**SUNDRY NOTICES AND REPORTS ON WELLS**  
*Do not use this form for proposals to drill or to re-enter an abandoned well. Use Form 3160-3 (APD) for such proposals.*

Northeast Drinkard Unit

#137

30-025-35557

B. O. P.

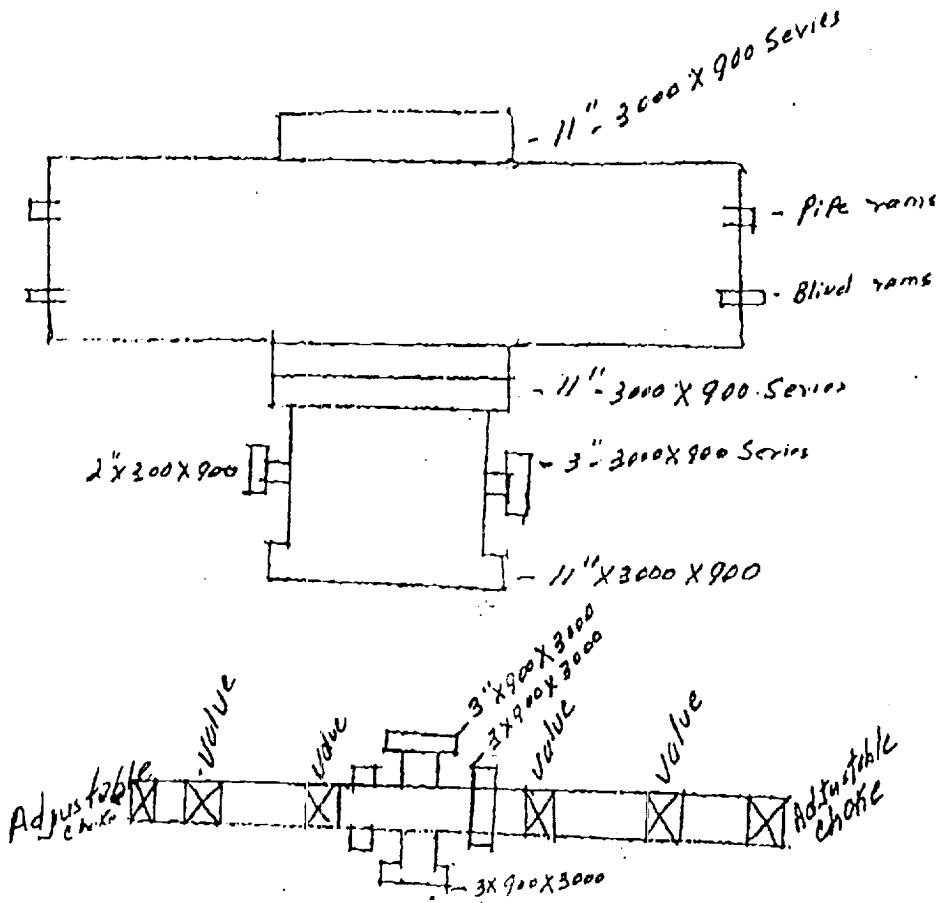
Apache Corporation hereby requests your waiver of the requirement that a remote control for the accumulator be used on the 3000 psi BOP provided for in our APD, dated 5-10-01. Also, attached is a revised drawing of the BOP to be used on this well, as the one submitted with our APD was in error.

Minimum working pressure of the blowout preventer and related equipment (BOPE) shall be 2000 psi with a minimum of One Annular Preventer or Two Ram-Type Preventers and a Kelly Cock/Stabbing Valve. A 2000 psi BOPE does not require a remote control for the accumulator.
